HOSHIZAKI AMERICA, INC.

SERVICE BULLETIN

SB02-0004

Subject: SD-450 STAND MOUNTING HOLE MODIFICATION

(Fig. 1)

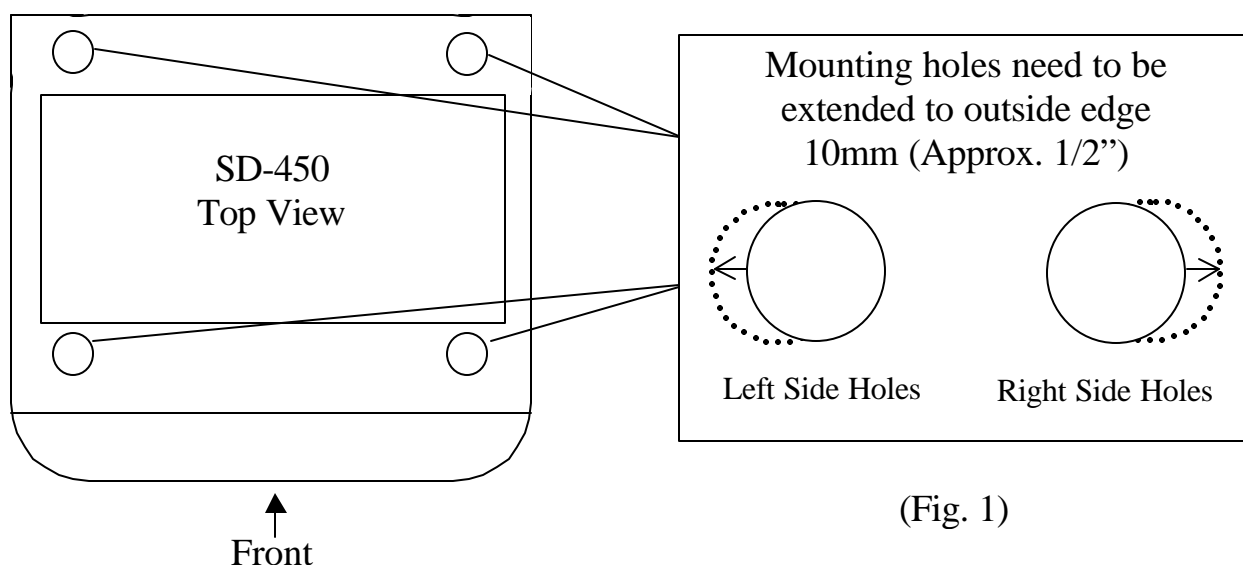
When installing a “later” model DCM-500B_F unit on an “earlier” model SD-450 it may be necessary to modify the mounting holes on the SD-450. This is due to a change in the leg hole spacing on the DCM series. In order for the DCM unit to mount properly you will need to extend the four 20mm mounting holes, on top of the SD-450 10mm or (Approx. 1/2”) to the outside edge of the stand. (See Fig. 1) This will allow alignment and installation of all 4 mounting bolts. To determine if your equipment falls within this category please refer to the chart below.

*****NOTE**:*** Only the SD-450s in this range are affected and then only when installing a “Later” model DCM-500B_F.
